Revised 1" IPS Threaded Fitting for Horizontal Drain Fittings and Universal Condensate Drains

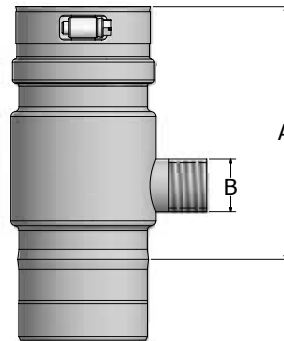
For sizes 6" - 16", Horizontal Drain Fittings and Universal Condensate Drains will now have a 1" IPS threaded fitting instead of the 5/8" straight tube. Sizes 3"-5" will remain 5/8" straight tube. See drawings and table for dimensions:
